Addendum #2

Attn: Estimator	Date: November 26, 2024
From: Lisa Donahue, Project Administrator	Pages: 25 (including cover page)
Re: Bullock Creek School District 2024 Bond Series 1	Project: 2025 Summer Projects HS/MS/Elem/Pine River/Floyd and Maintenance Building
CC:	Proj. #: A24907

ADDENDUM #2

Project: No. 24-120 2023 Bond – Series 1 2025 Improvements

- CONSTRUCTION GENERAL NOTES**
- ALL DIMENSIONS ARE TO FACE OF MASONRY, FACE OF STUD, AND/OR CENTERLINE OF STEEL, UNLESS NOTED OTHERWISE.
 - COORDINATE ALL WORK WITH GENERAL, MECHANICAL AND ELECTRICAL TRADES. VERIFY EXACT SIZE AND LOCATION OF ALL OPENINGS REQUIRED OF THESE AND OTHER TRADES.

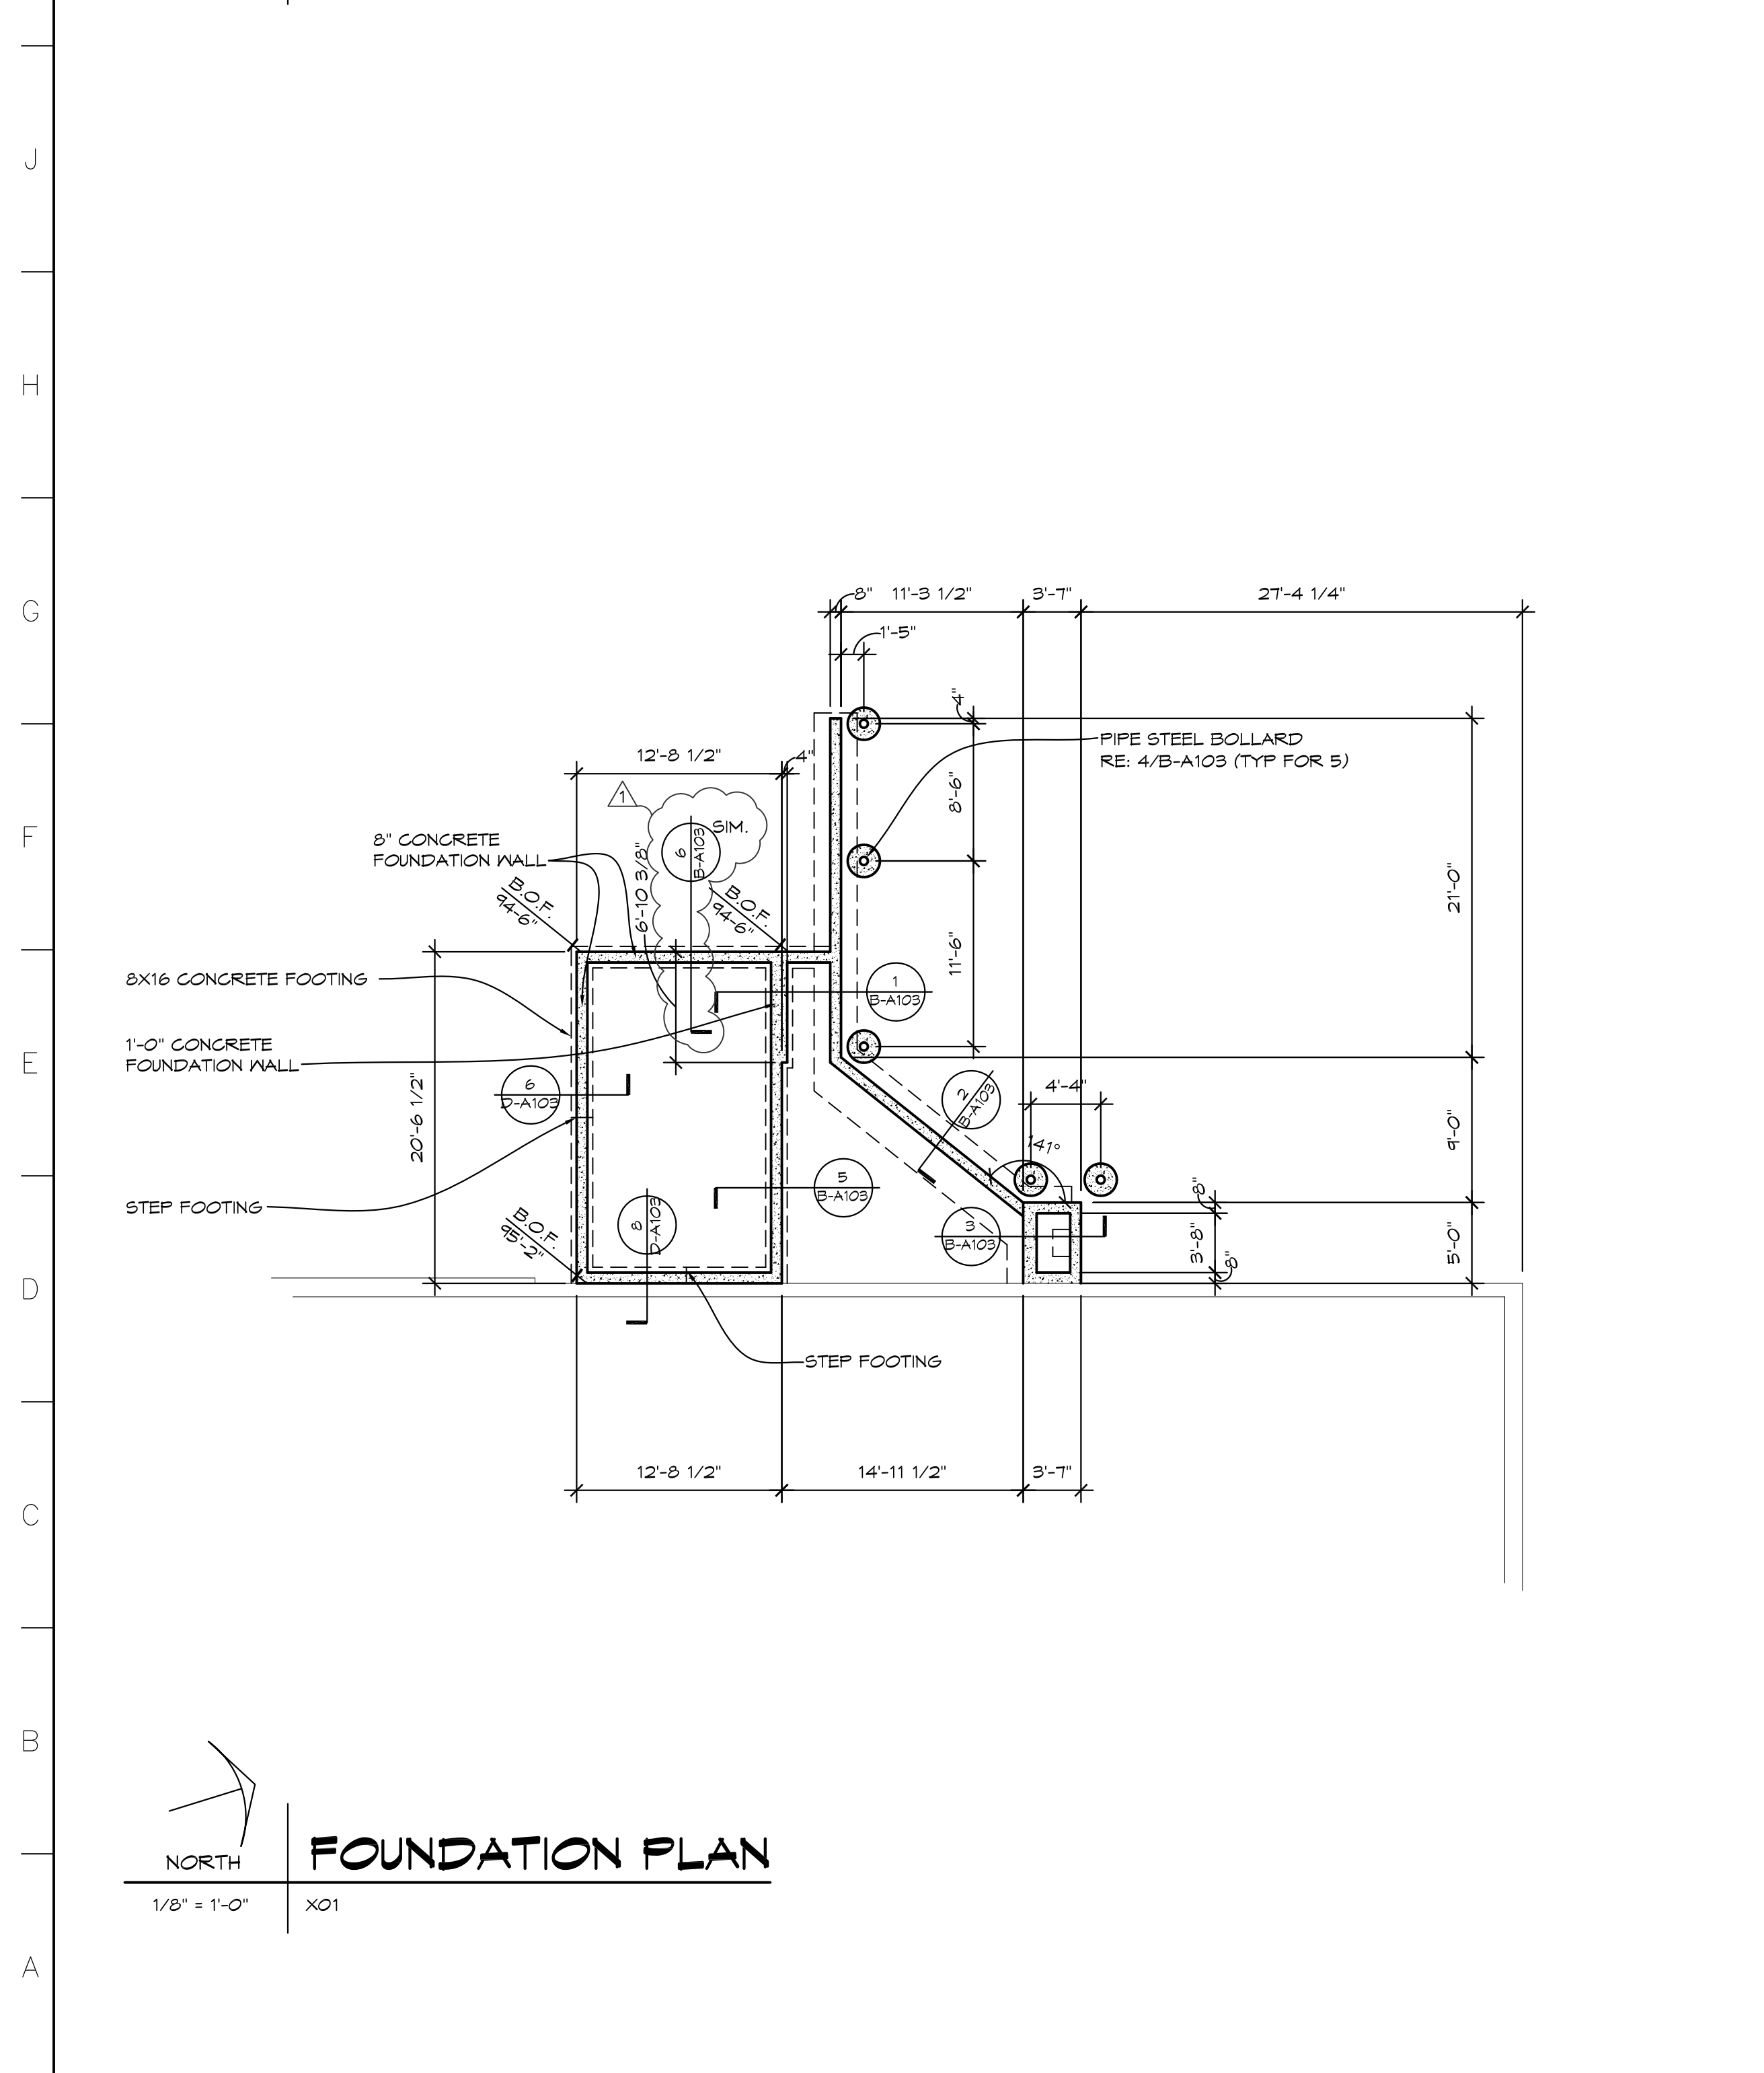
- Item #M1: Revise Sheet B-A102 as follows:
- a. Remove and reinstall existing fin tube in Storage 129 above door for new wall opening. Reinstall fin tube with bottom of enclosure even with new door opening. Re-pipe hot water heating supply and return to fin tube exposed down along wall.
 - b. Install new isolation valves in hot water heating supply and return lines feeding existing fin tube and cabinet unit heater.

7 DETAIL
3/4" = 1'-0" MSEC06

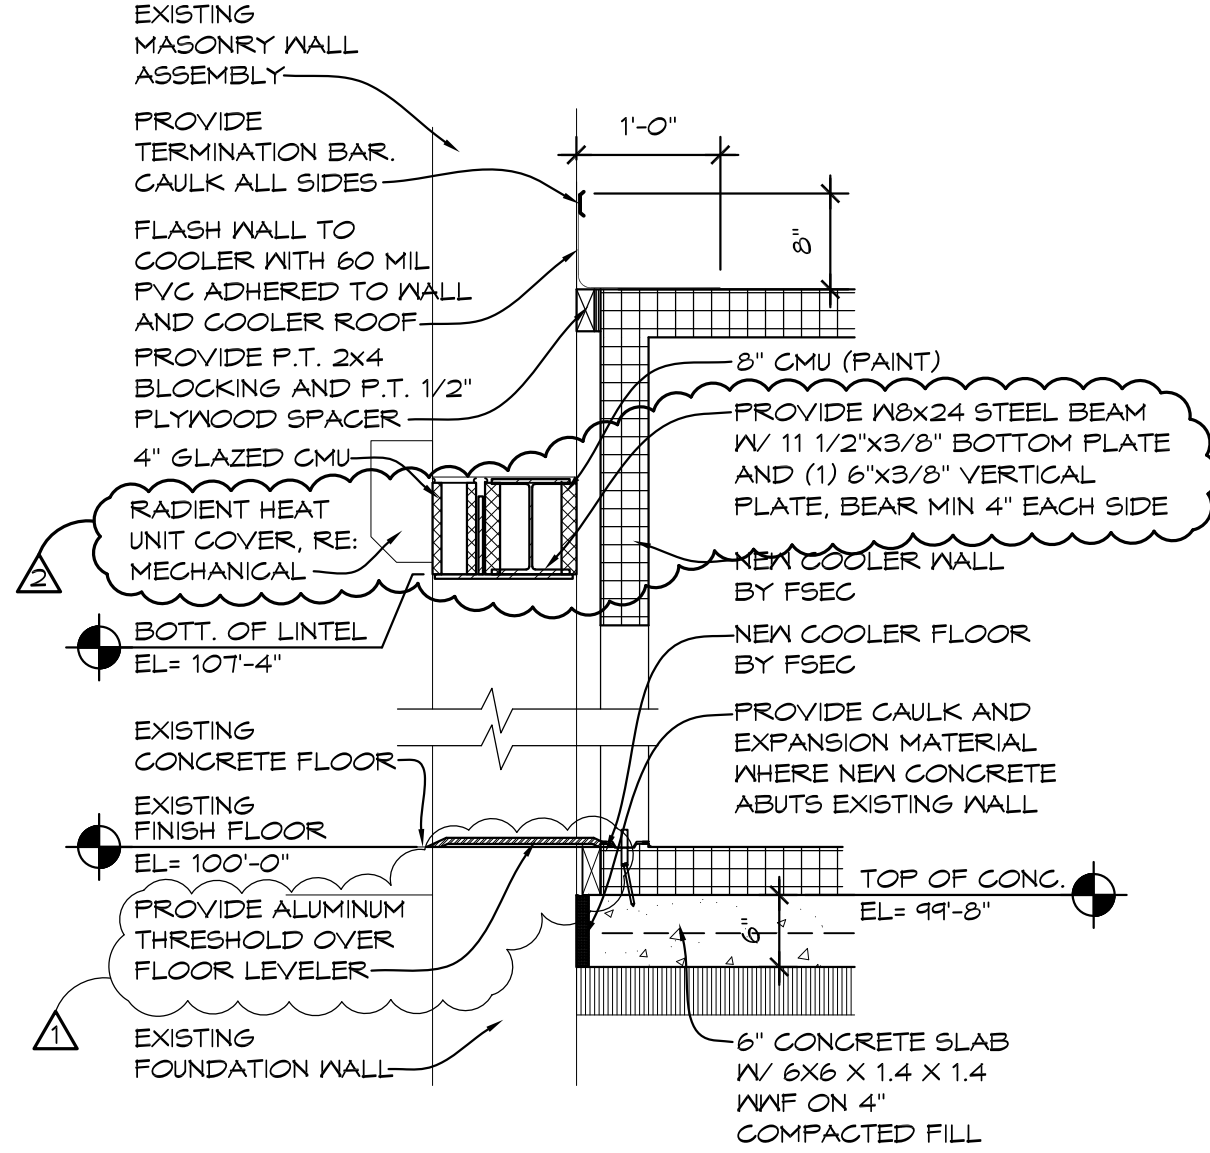
- Item #A1: Revise Sheet B-A103 as follows:
- a. Revise detail 7 to show W8x24 steel beam lintel with 11 ½" x 3/8" bottom plate and 6" x 3/8" vertical plate. Show radiant heat unit cover to be reinstalled.
